8150 Sunset Blvd development

Case No.: VTT-72370-CN CPC-2013-2551-CUB-DB-SPR
CEQA No.: ENV-2013-2552-EIR

SAVE SUNSET BOULEVARD - DEIR COMMENTS ON 8150 SUNSET

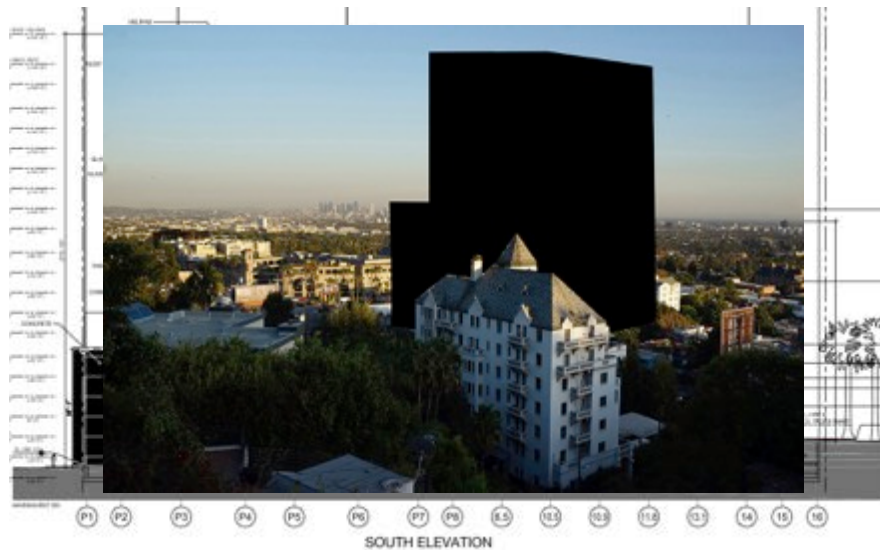
On the left is the 2 story National Historic Register building, The Andalusia; directly across the street is the 8150 project site where the 20+ story building will shadow it.

Traffic objections to DEIR Alternative 9

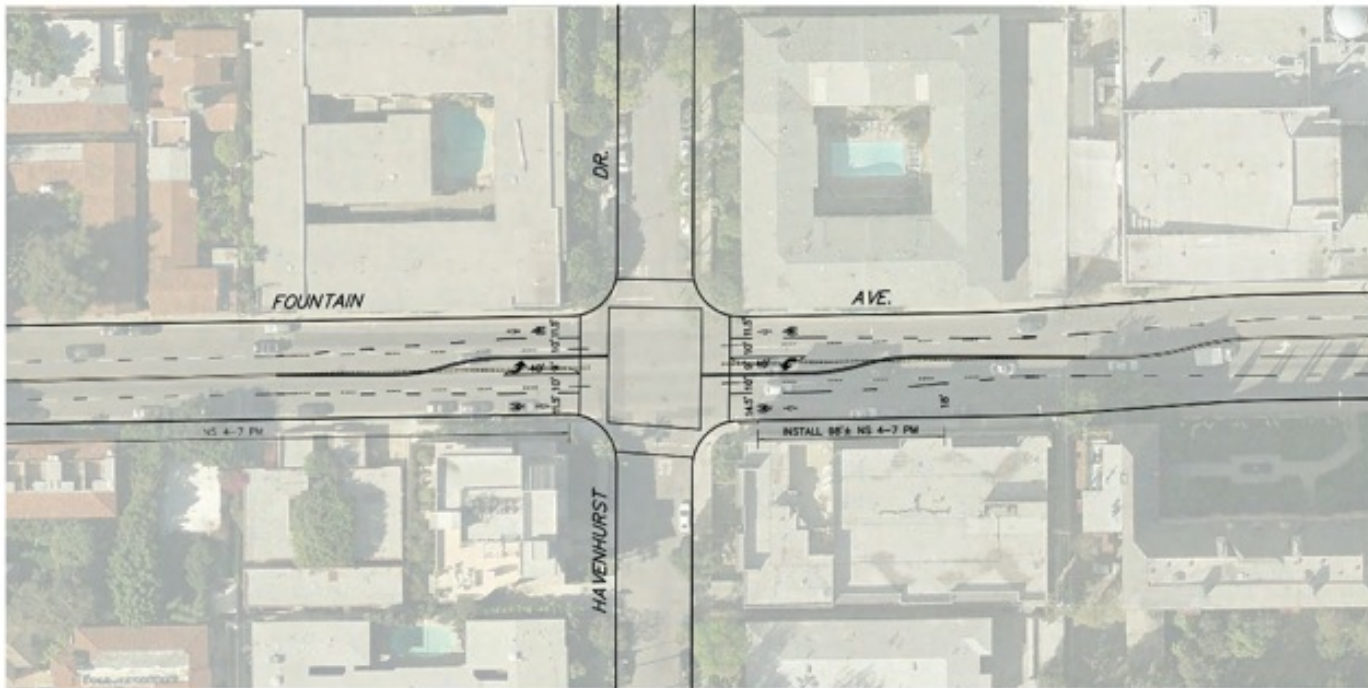
The impacts from construction and operation are so far reaching in alternative 9 they are an untenable burden for not only residents but commuters who use Sunset Blvd, Laurel Canyon Hollywood Blvd, Laurel, Fairfax Ave and Fountain.

Alternative 9 is a completely different project, with completely new building configurations and significant changes to proposed traffic patterns and traffic flow than what the current Traffic Study was previously performed for. A New traffic study should be required and performed for this new Alternative 9, and any other configuration that changes or alters traffic flow, travel lanes, traffic circulation, ingress and egress to project site for vehicles, trucks and bicycles on Havenhurst, Fountain Ave, Sunset Blvd and Crescent Heights. The new traffic study needs to include cumulative impacts from other projects approved and planned within one and one half miles of the project site.

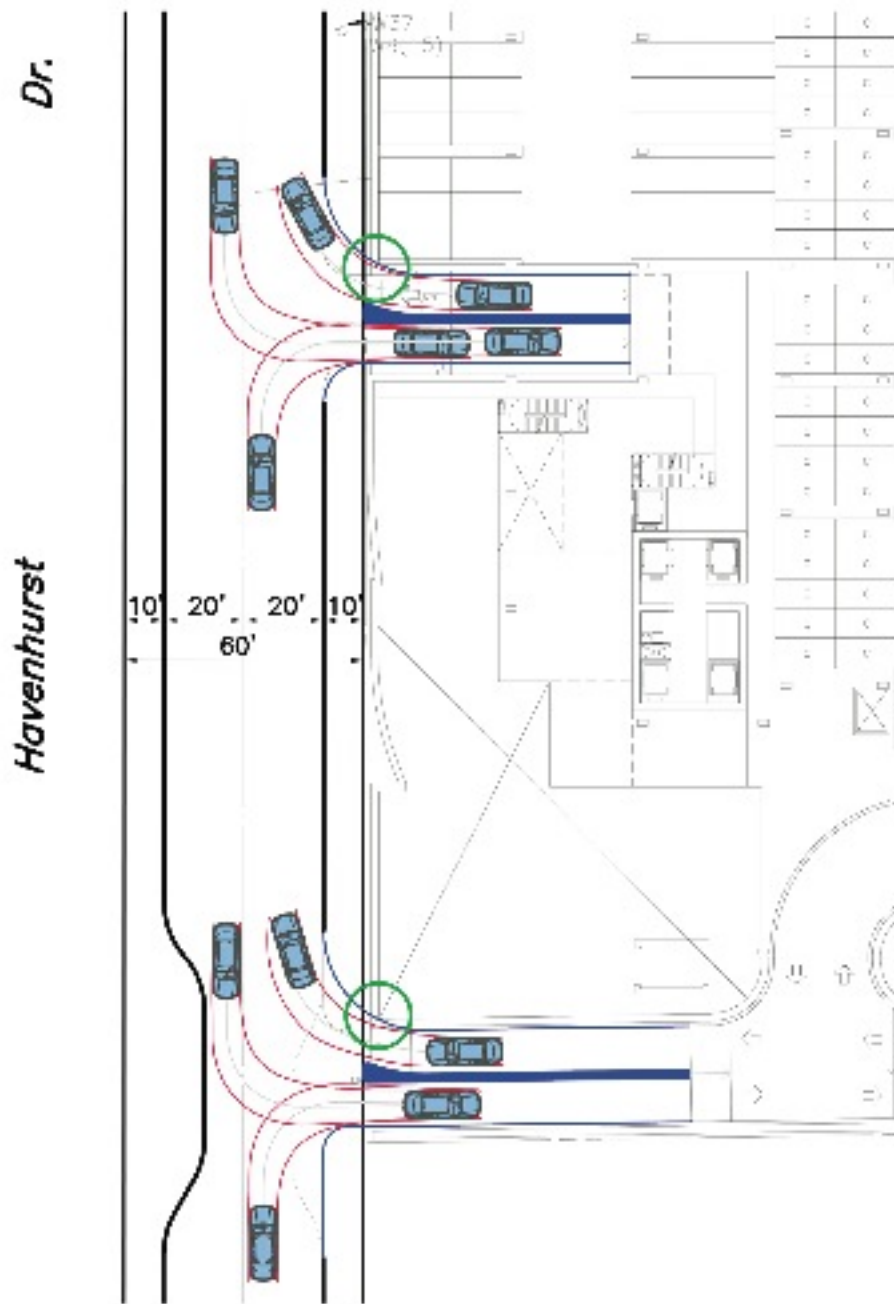
Delivery trucks parked on Sunset Blvd would also greatly shorten turn lane length availability for the proposed Sunset Blvd right turn lane and vehicles turning from Sunset Blvd to southbound to Crescent Heights. The right turn lane on Sunset Blvd would overflow to other lanes making Sunset Blvd access for new residents, patrons and all regular vehicle travel near impossible. The DEIR does not address this and is deficient.

Additionally, delivery trucks parked on Crescent Heights would hinder ingress, egress to and from the parking garage access and block vehicle site view on oncoming traffic from Laurel Canyon. Crescent Heights parking garage is proposed to be a very high volume use from employees, patrons, valet set up, residents and residents guests turning left and right into and out of the Crescent Heights parking garage. The DEIR does not address this and so is fatally flawed.

Delivery trucks parked on Sunset Blvd and Crescent Heights would also eliminate or hinder use of a curbside resident, patron and employee passenger pick up and drop off for ride services like Taxi, Lyft and Uber. Easy passenger pick up and drop off areas will be essential for smooth east-west travel on Sunset Blvd and north-south travel on Crescent Heights. An off street cutout area is necessary for Sunset Blvd to accommodate passenger drop off and pick up with out adding more strain on Crescent Heights parking garage access and surrounding neighborhood streets. The DEIR does not address this and so is fatally flawed.

This is the proposed " High Quality Transit Stop"

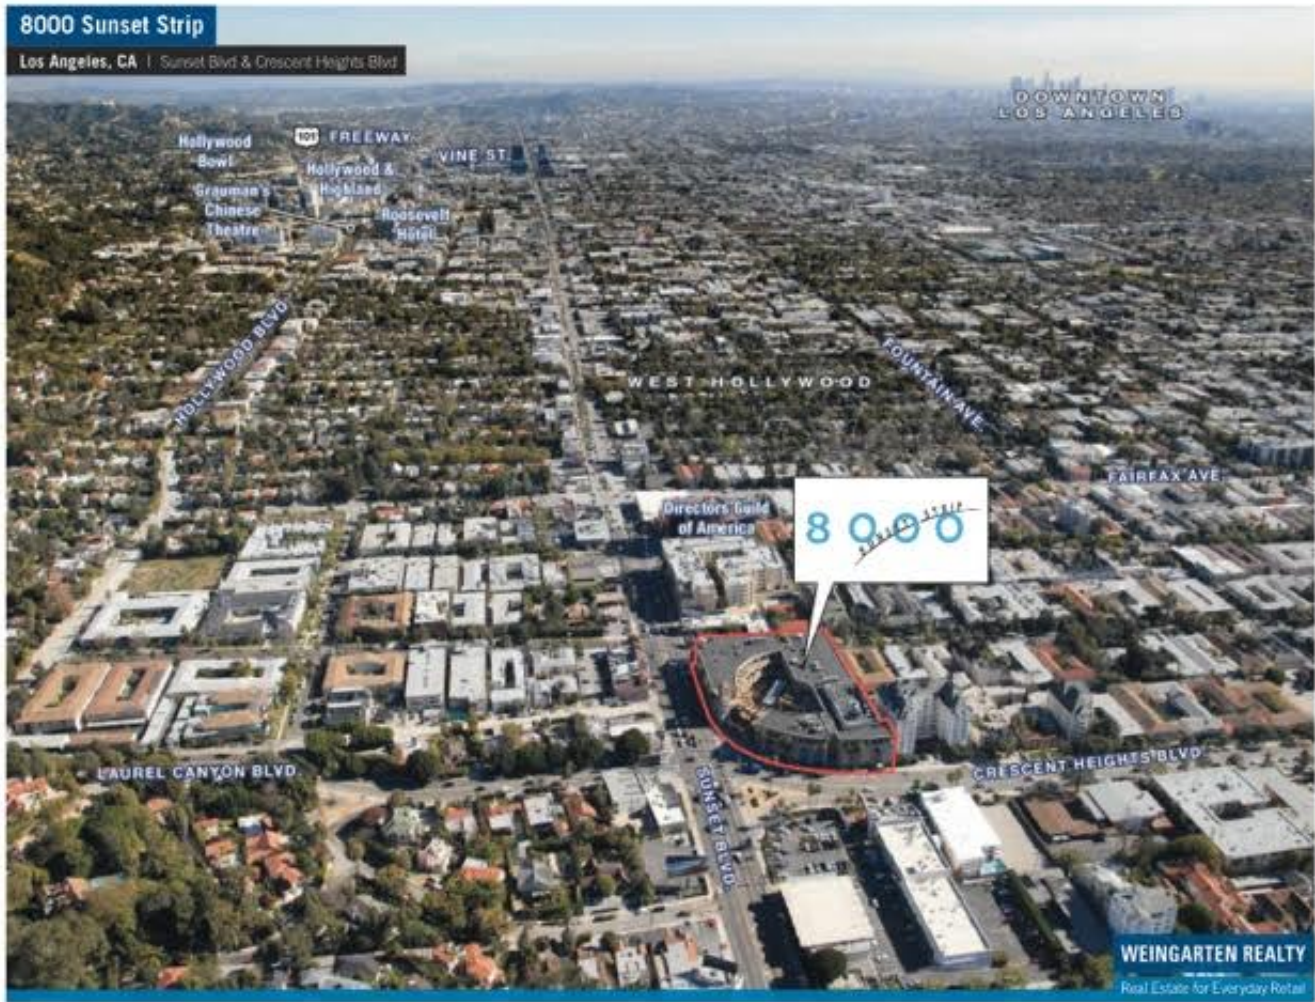
Bus stop Fairfax Ave south bound at Sunset-No shelter or amenities

This is the proposed " High Quality Transit Stop"

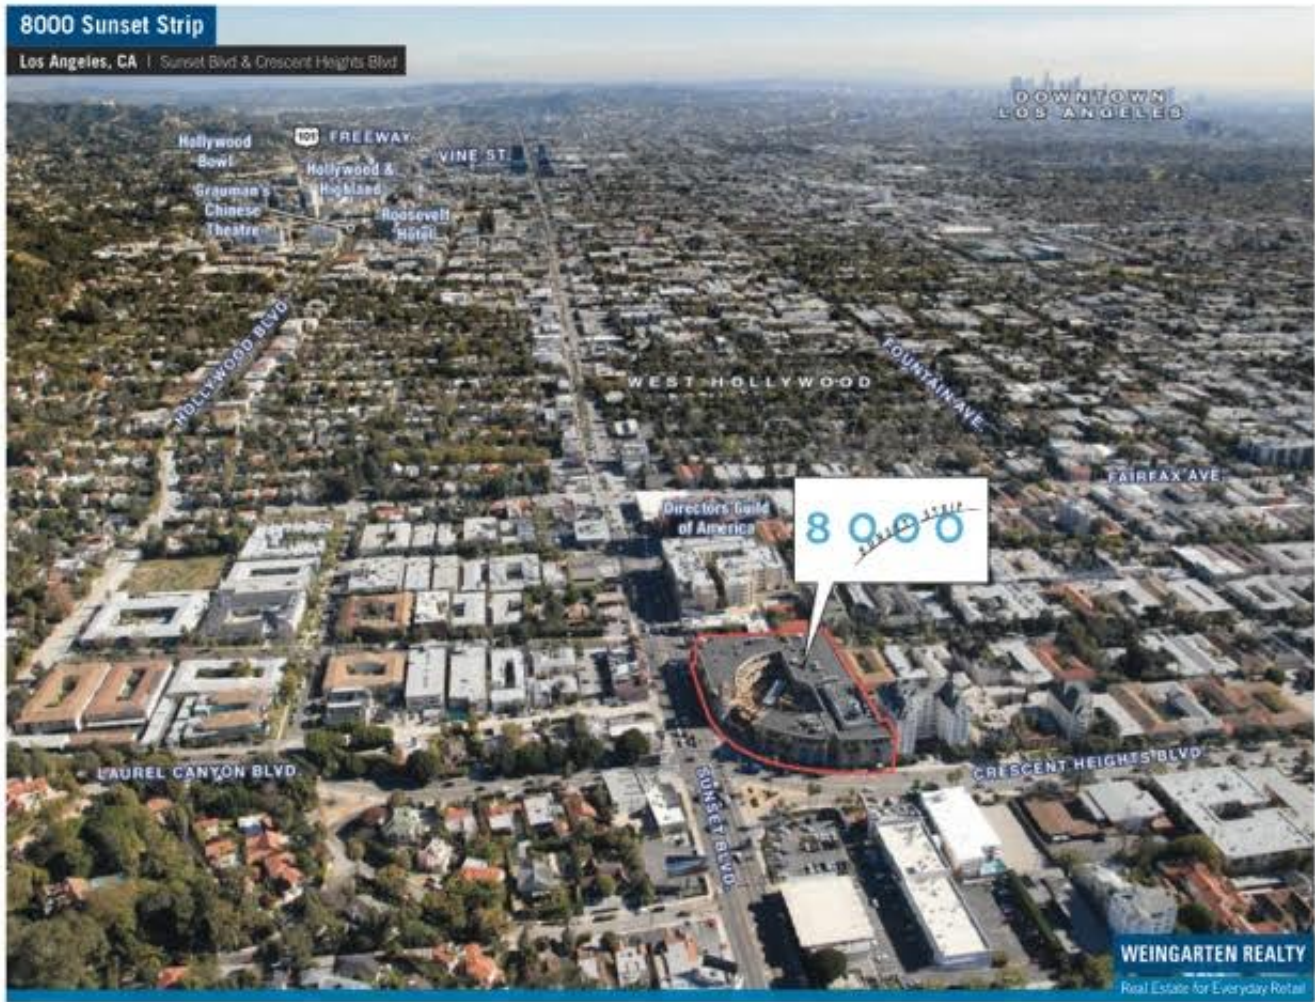
Bus stop Fairfax Ave south bound at Sunset-No shelter or amenities
